Title of Change:	Additional Mold Compound Supplier and Leadframe Dimension Change for D2PAK Case Outline 418AJ from onsemi Suzhou, China
Proposed First Ship date:	11 Sep 2024 or earlier if approved by customer
Contact Information:	Contact your local onsemi Sales Office or Sunny.Hou@onsemi.com
PCN Samples Contact:	Contact your local onsemi Sales Office. Sample requests are to be submitted no later than 30 days from the date of first notification, Initial PCN or Final PCN, for this change. Samples delivery timing will be subject to request date, sample quantity and special customer packing/label requirements.
Additional Reliability Data:	Contact your local onsemi Sales Office or Jutta.Xu@onsemi.com
Type of Notification:	This is a Final Product/Process Change Notification (FPCN) sent to customers. FPCNs are issued 90 days prior to implementation of the change. onsemi will consider this change accepted, unless an inquiry is made in writing within 30 days of delivery of this notice. To do so, contact PCN.Support@onsemi.com

Final Product/Process Change Notification

Document #:FPCN25822X

D²PAK-3 (TO-263, 3-LEAD)
CASE 418AJ
ISSUE F

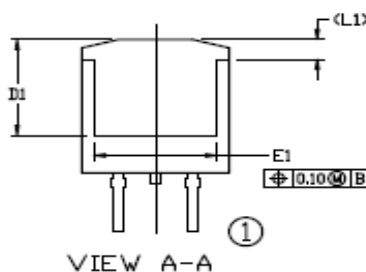
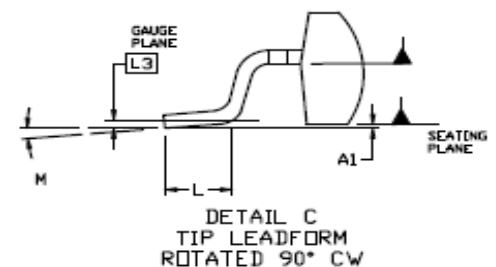
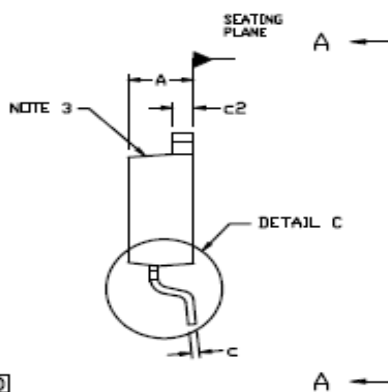
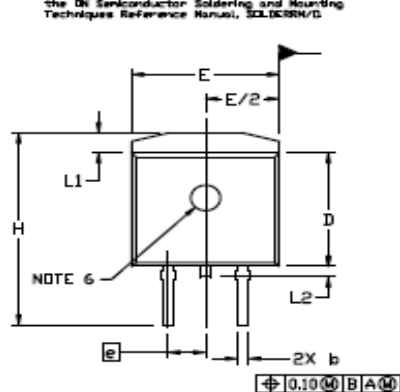
Mold feature optional location & appearance comparison:

From	To
Appearance change	Optional mold feature located in center 	Optional mold feature located in bottom left
